# Technical Service Information

## FORD A4LD OVERDRIVE SPRAG CHANGE

Figure 2

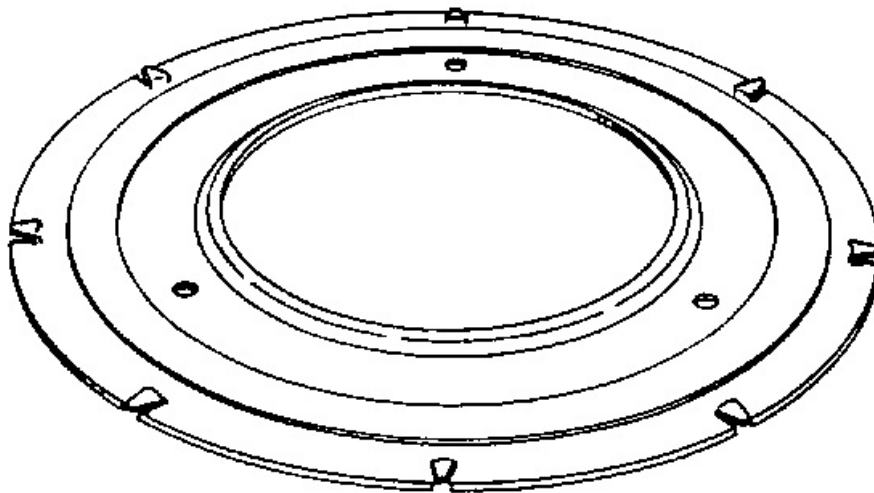
**OVERDRIVE RING GEAR IDENTIFICATION**

**PREVIOUS DESIGN WITH STEEL CAGED SPRAG, DIMENSION "A" = .335"**  
**DESIGN LEVEL WITH PLASTIC CAGED SPRAG, DIMENSION "A" = .295"**  
**COMPATIBLE PARTS MUST BE USED TOGETHER**

Figure 1

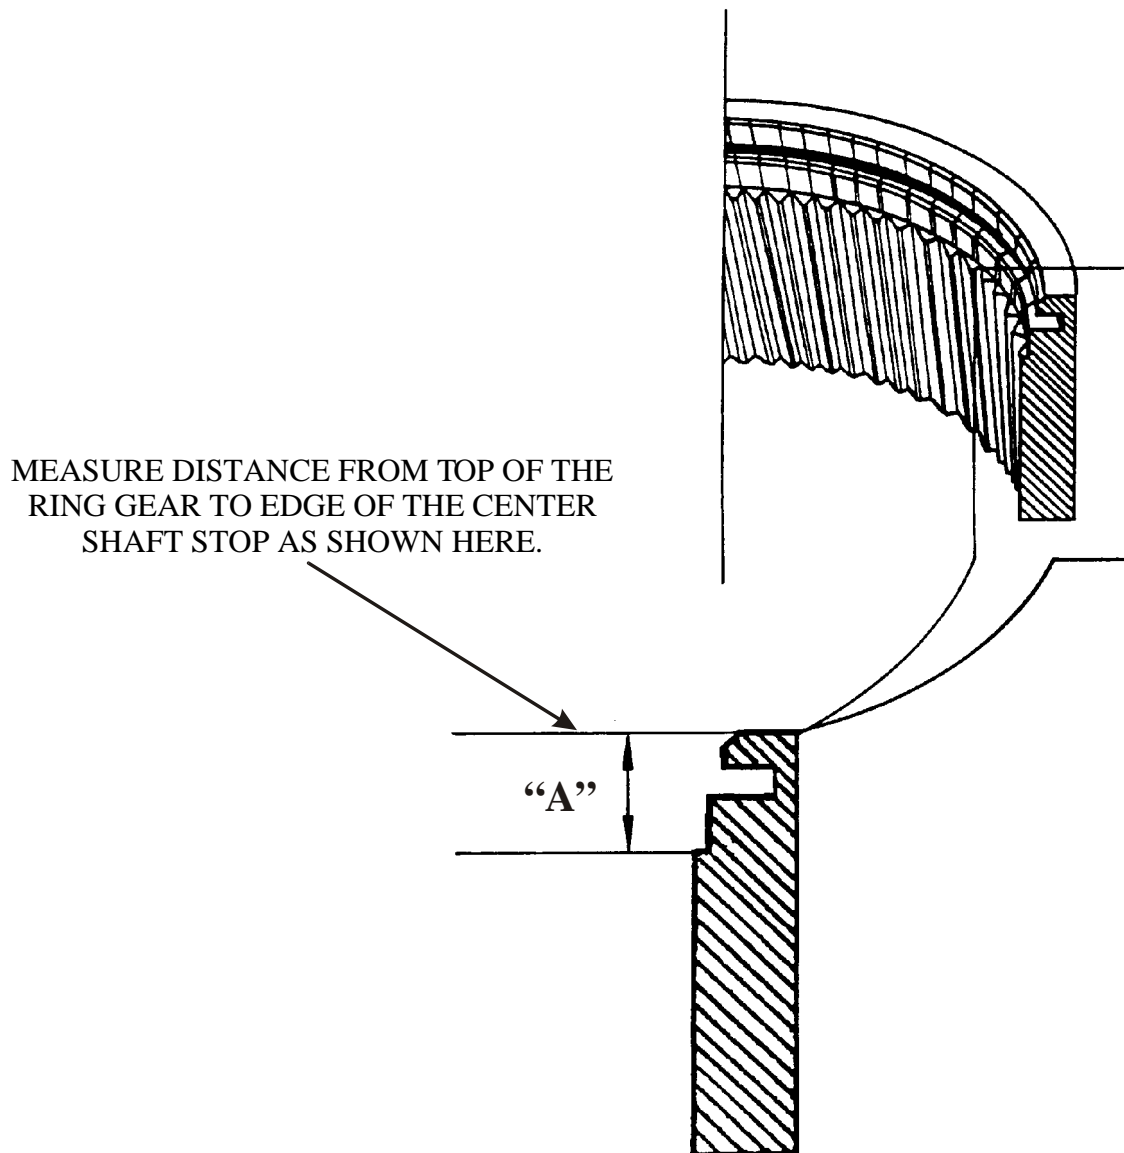
**CHANGE:** Vehicles equipped with A4LD transmissions built after June 9, 1992 contain a plastic caged overdrive sprag assembly that is no *longer* serviced. The previous design steel caged sprag and all related parts must be used for service.

**REASON:** Ford Motor Co. felt that the plastic caged overdrive sprag assembly could be damaged upon disassembly from the overdrive center shaft.

- (1) **OVERDRIVE SPRAG ASSEMBLY** - Previous design steel caged sprag must be used, as the plastic caged sprag is no longer serviced, which requires the use of the previous design ring gear and the previous retaining washer (See Figure 3).
- (2) **OVERDRIVE RING GEAR** - Previous design ring gear must be used to accommodate the steel caged sprag and retaining washer that must be used. Measure the overdrive ring gear, as shown in Figure 2, to ensure you have the proper one.
- (3) **RETAINING WASHER** - Previous design retaining washer shown in Figure 1 must be used to accommodate the previous design overdrive ring gear.

### PREVIOUS DESIGN RETAINING WASHER
